General Arrangement Proposed - RF Roof

B	ISSUED FOR DEVELOPMENT APPLICATION S96	01/2017
REV.	DESCRIPTION	DATE

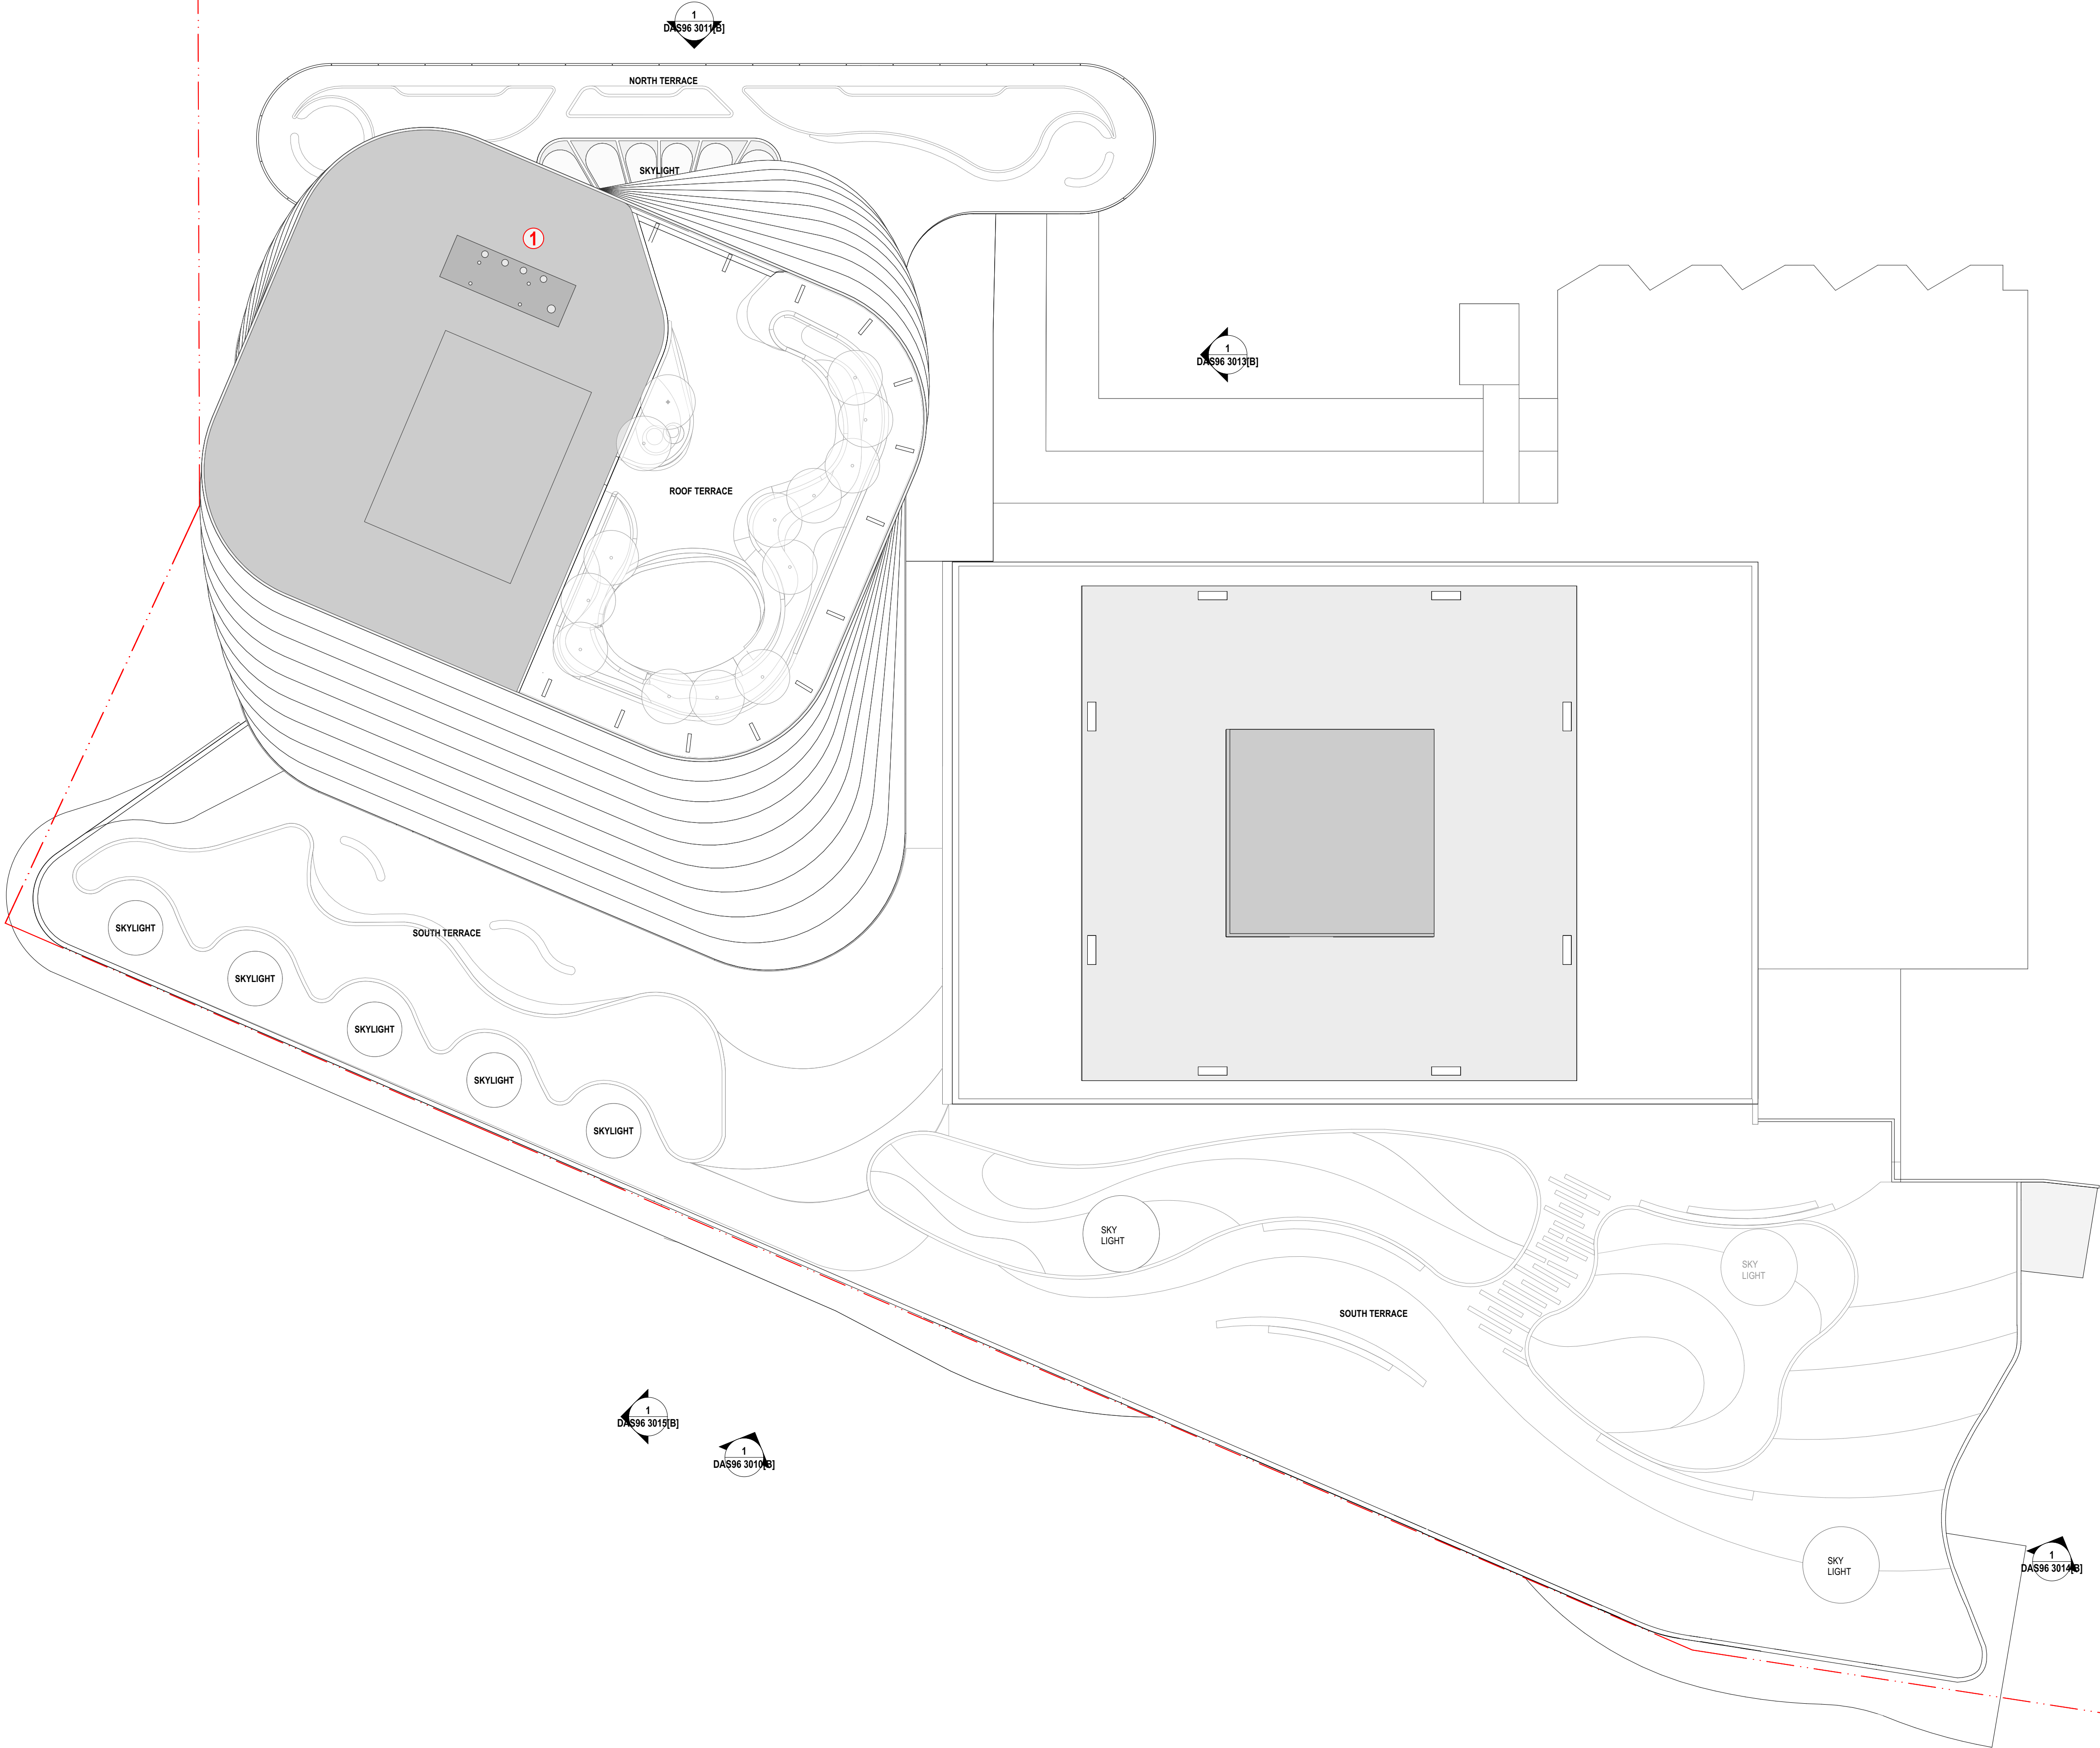
CHANGES

- ① SUPERLAB FLUES
